Access Compliance Report Public Rights-of-Way (Curb Ramps)

Main Street: MCFADDEN_AVE **Cross Street:** WILSON_ST **Location:** NW

ADA ID: RPRK210930113620 **Ramp Type:** Type 1 - Perpendicular Diagonal Initial Pass/Fail: Fail **Overall Compliance:** No **Severity Score:** 15

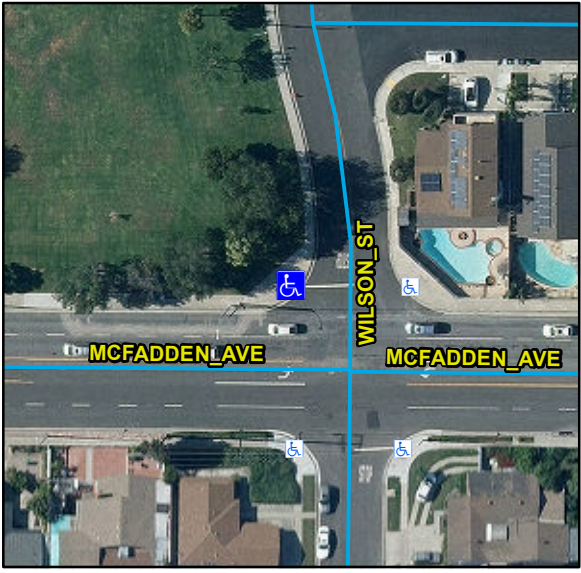
Compliance	Description	Data	Compliance	Description	Data
N/A	Ramp Length (in)	80	N/A	Flare Type LT	
Yes	Ramp Width (in)	48			N/A
No	Ramp Run Slope (%)	11.3	N/A	Flare Slope LT (%)	N/A
Yes	Ramp Cross Slope (%)	1.3	N/A	Flare Traversable LT	N/A
N/A	Landing Present	N/A	N/A	Flare Type RT	
N/A	Landing Length (in)	N/A			N/A
N/A	Landing Width (in)	N/A	N/A	Flare Slope RT (%)	N/A
N/A	Landing Run Slope (%)	N/A	N/A	Flare Traversable RT	N/A
N/A	Landing Cross Slope (%)	N/A	N/A	DWS Provided	N/A
N/A	Landing Movement Obstructed?	N/A	N/A	DWS Contrast	N/A
	Landing Movement Type	N/A	N/A	DWS Length (in)	N/A
N/A	Landing Shared	N/A	N/A	DWS Full Width	N/A
N/A	Clear Space	Yes	N/A	DWS Offset Left (in)	N/A
N/A	Clear Space To Crosswalk (in)	N/A	N/A	DWS Offset Right (in)	N/A
N/A	Marked Crosswalk 1	No	N/A	Marked Crosswalk 2	No
	Crossing 1 Direction	S		Crossing 2 Direction	E
	Marked Crosswalk 1 Width (in)	N/A		Marked Crosswalk 2 Width (in)	N/A

Possible Solutions:
Remove & Replace Curb Ramp With Two New Directional Ramps or Equivalent.

OC Std/PROW:
 R204.3, R304.2.2, STD 1115
